**Re: 40 to 60 Emma Street  
Comments for Site Plan Stage  
Project No.: 300056012.0000**

The application will be required to obtain site plan approval. As comments related to the site plan stage are more detailed, these comments have been provided separately from the Official Plan/Zoning Amendment applications.

Enclosure(s)      Red-Marked Pages from Servicing Brief

SHEET NUMBER:  
SERV-1

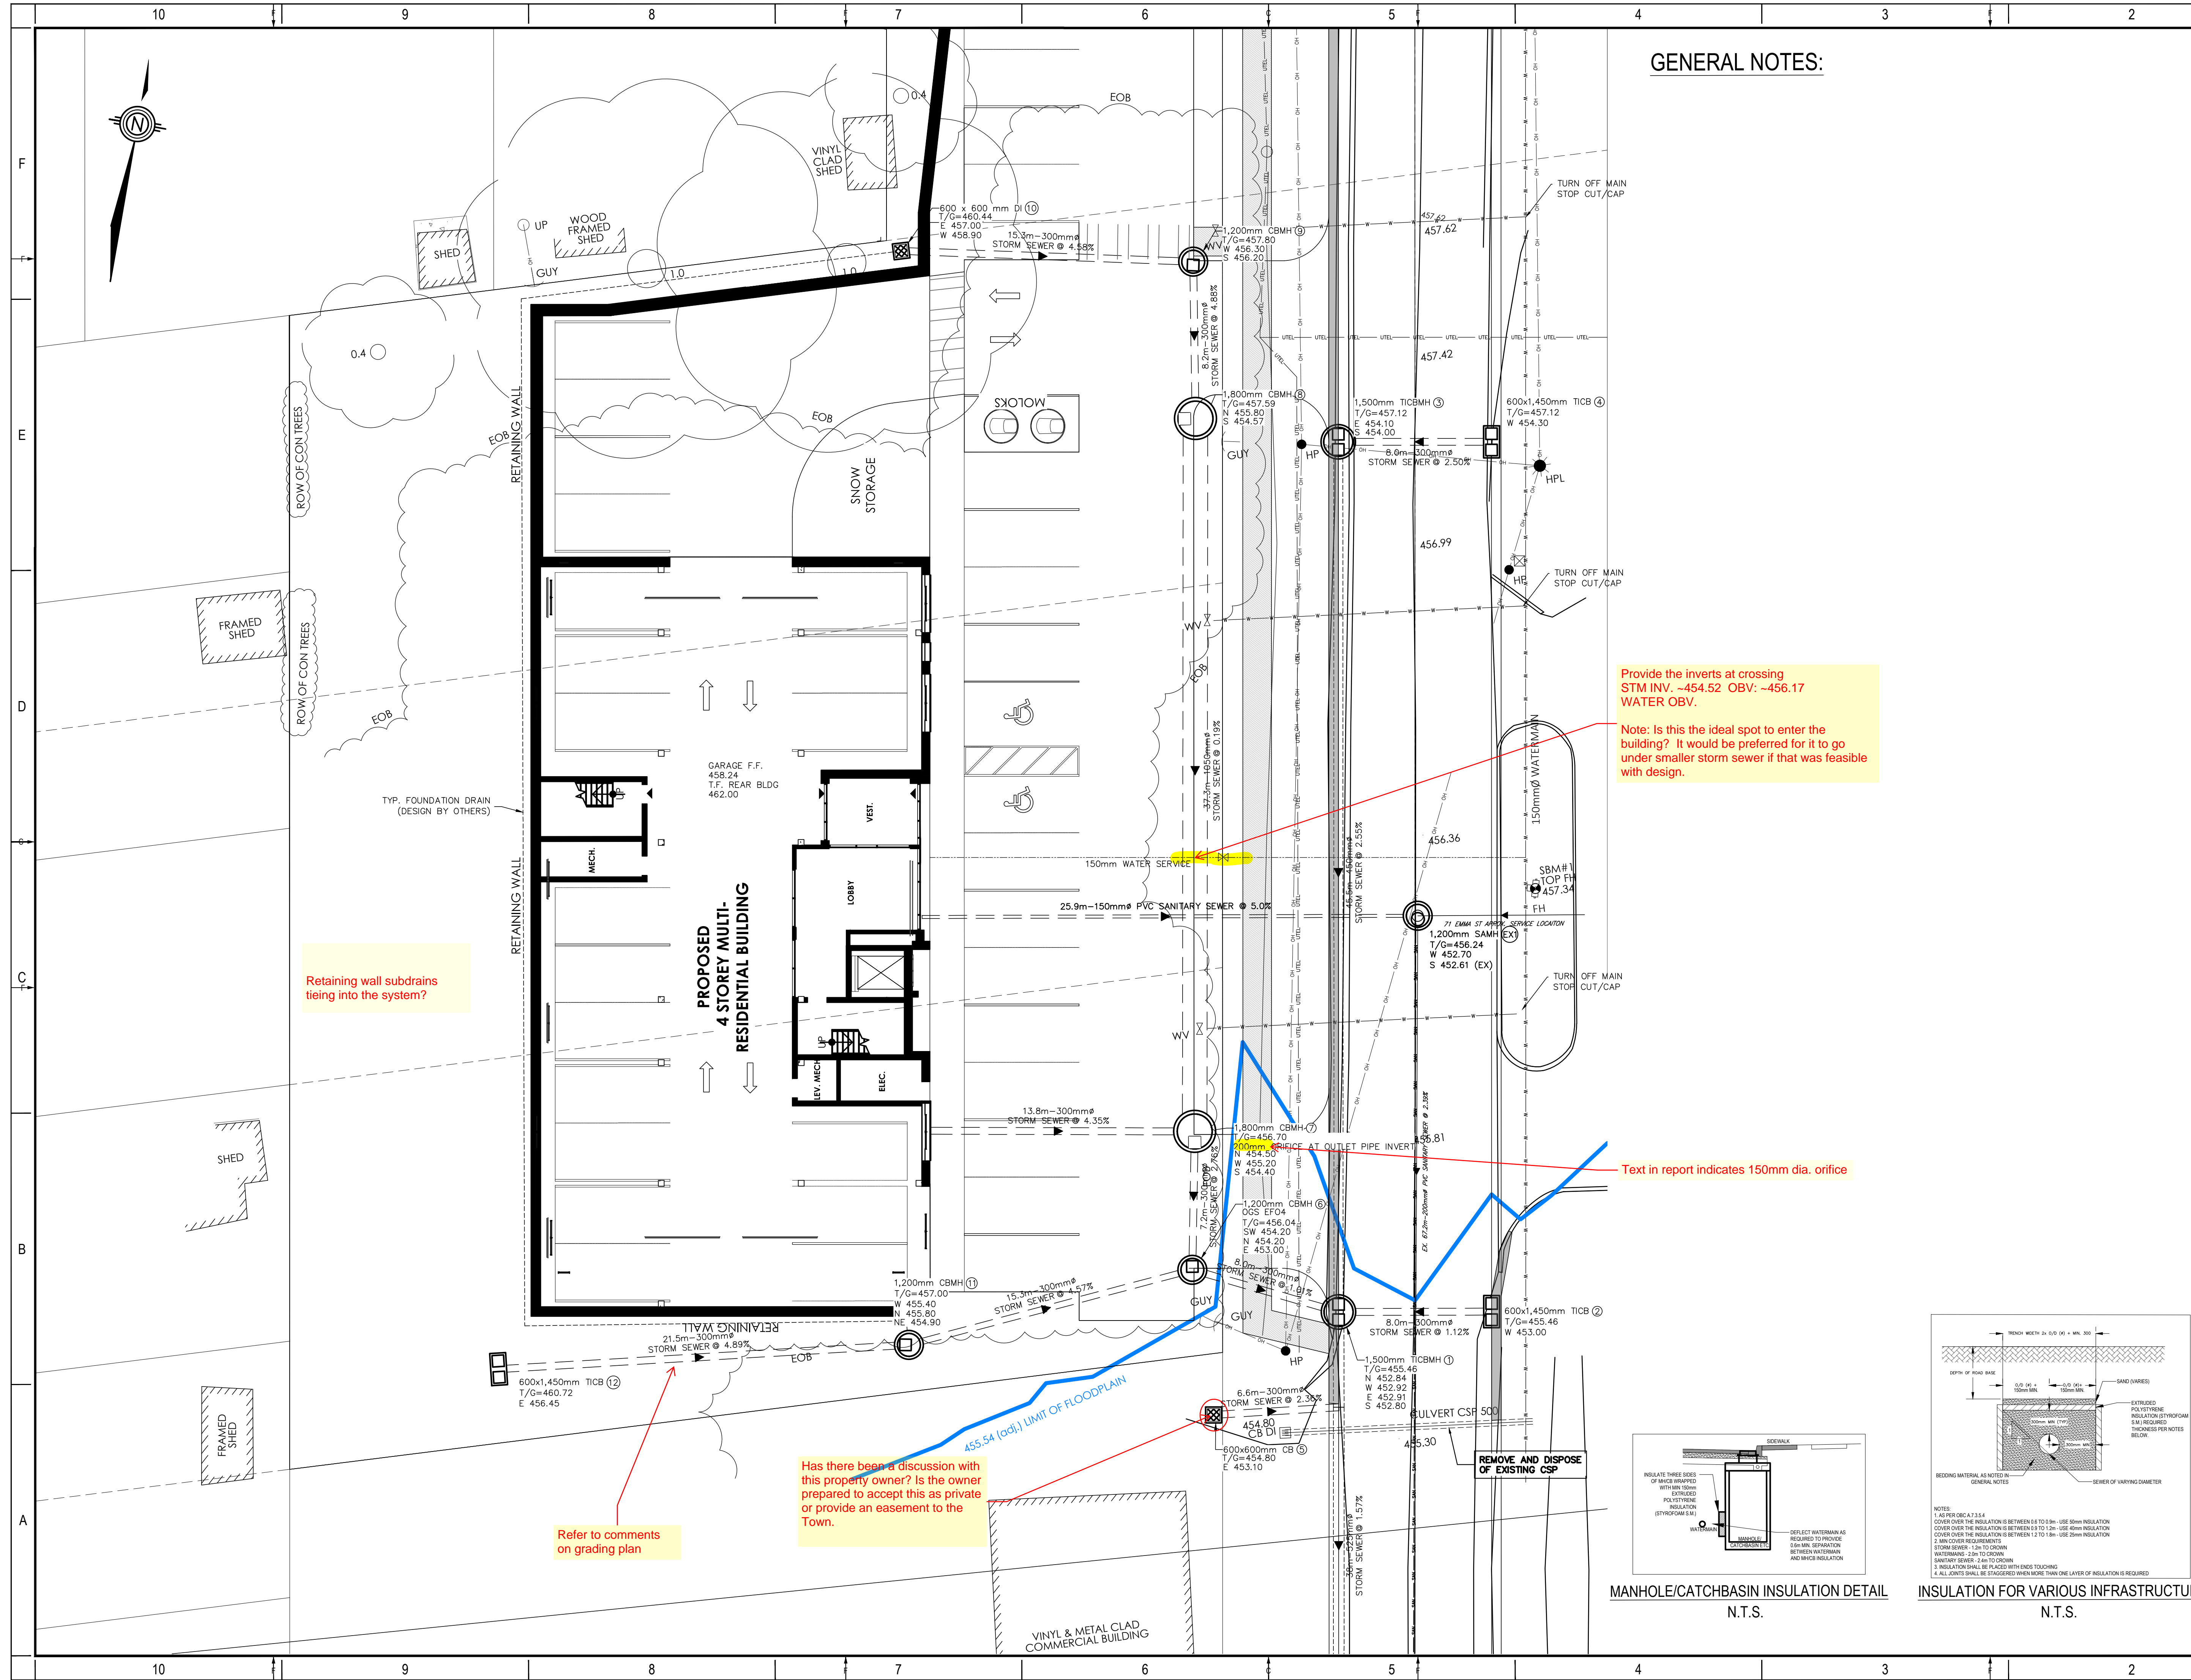
Provide the inverts at crossing STM INV. -454.52 OBV: -456.17 WATER OBV.  
Note: Is this the ideal spot to enter the building? It would be preferred for it to go under smaller storm sewer if that was feasible with design.

Text in report indicates 150mm dia. orifice

Refer to comments on grading plan

Has there been a discussion with this property owner? Is the owner prepared to accept this as private or provide an easement to the Town.

PROJECT NO: 231-103	DATE: JUNE 2024
ORIGINAL SCALE: 1:250	IF THIS BAR IS NOT 25mm LONG, ADJUST YOUR PLOTTING SCALE.
DESIGNED BY: K.PILON	
DRAWN BY: K.PILON	
CHECKED BY:	
TITLE: <b>PLAN AND PROFILE 40 EMMA STREET GRANDVALLEY</b>	
SHEET NUMBER: P&P1

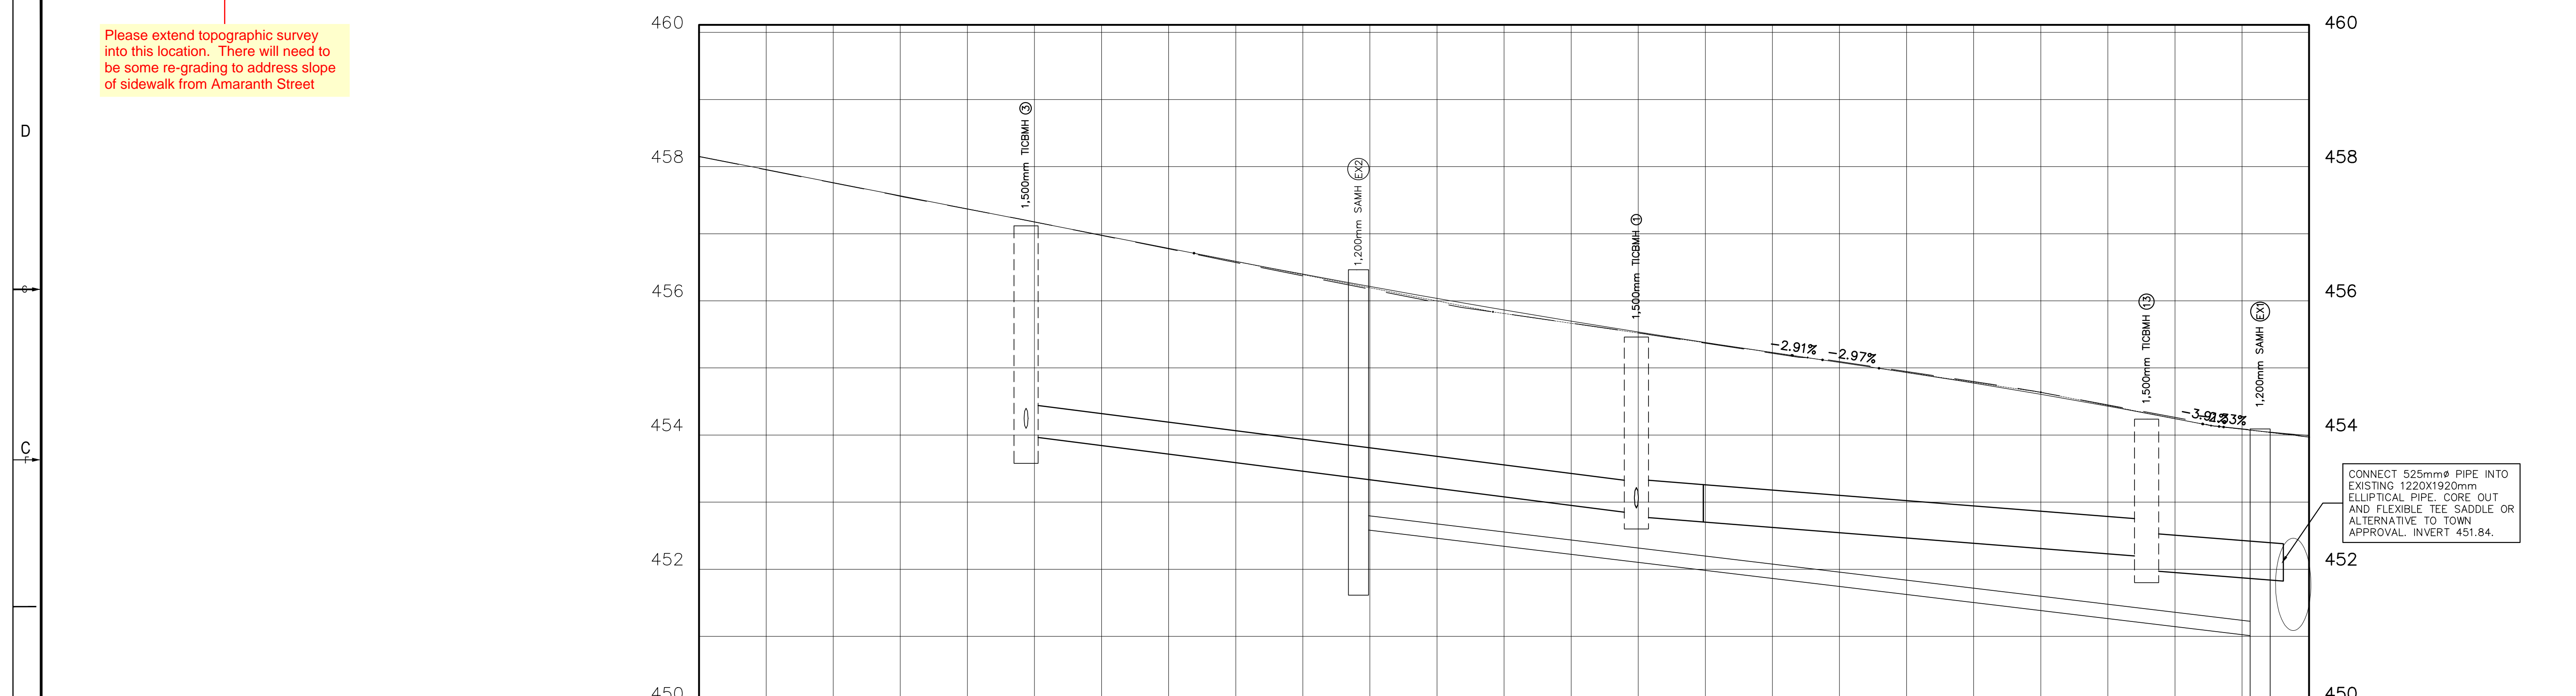
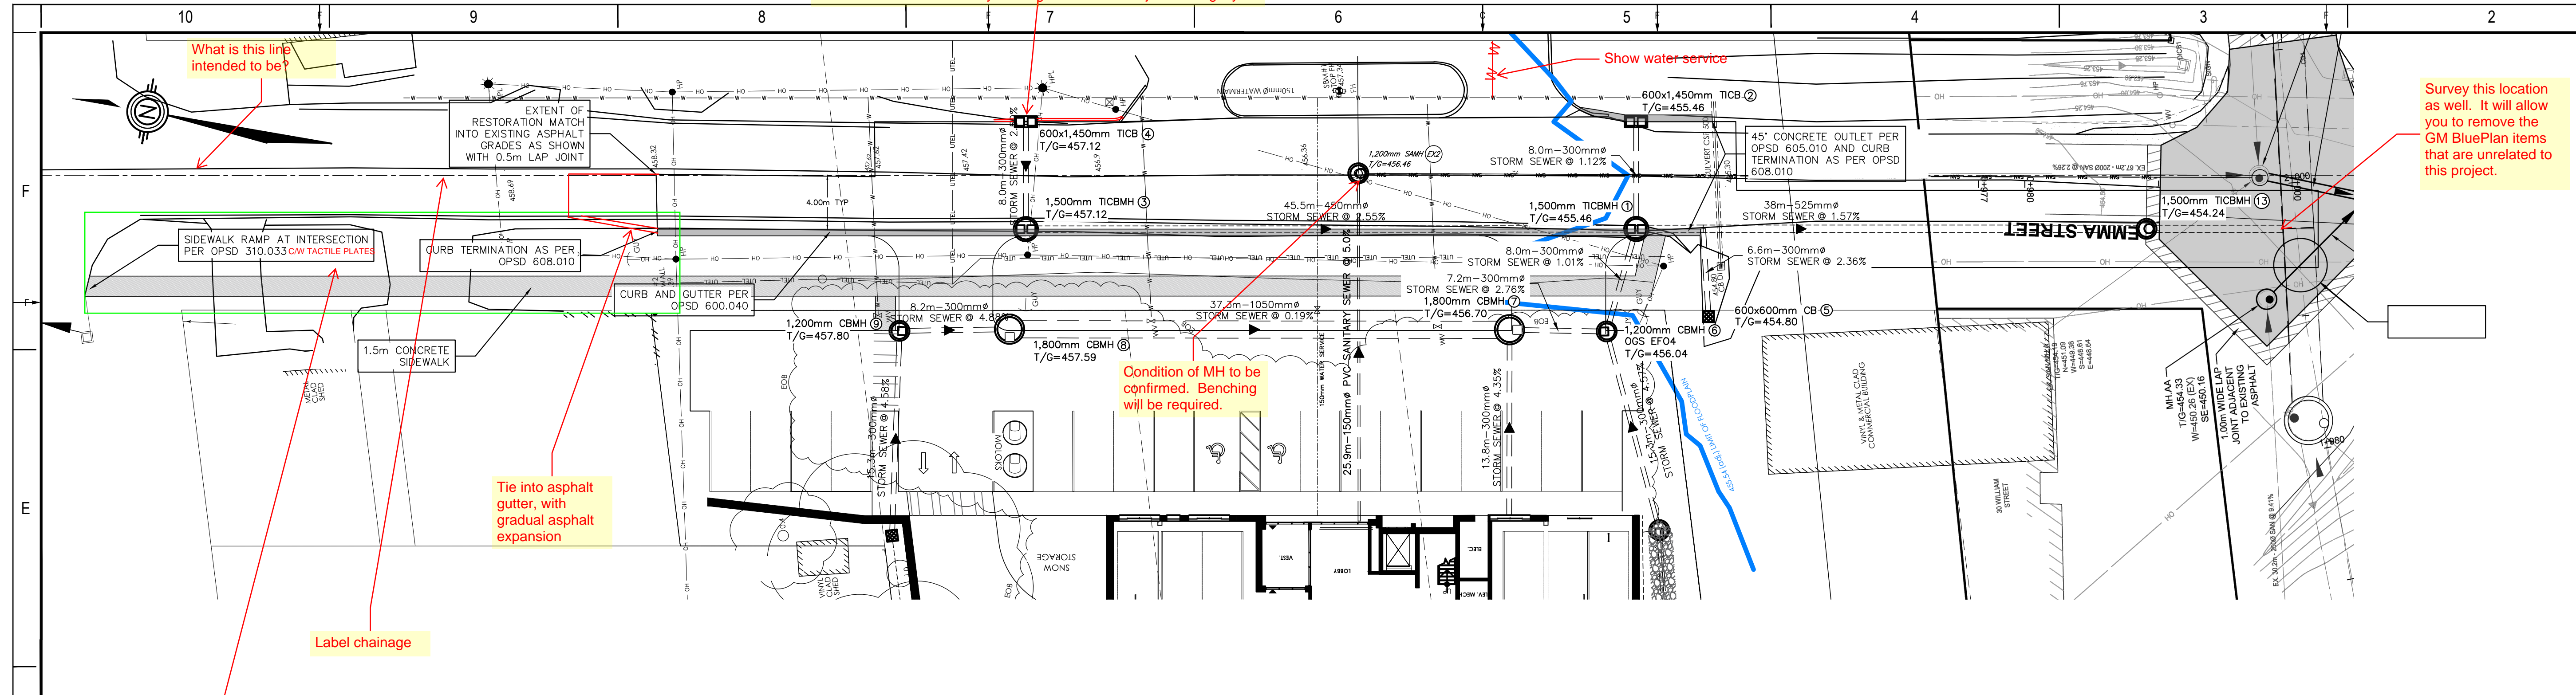
Extend curb and gutter OPD 600.040 to min. 1m past DCB and terminate. Tie into driveway curbing. Will need to adjust CB slightly.

The difference between the N and S invert should be at least 0.75m to match obvert to obvert. Modify drawing as a result.

Please extend topographic survey into this location. There will need to be some re-grading to address slope of sidewalk from Amaranth Street
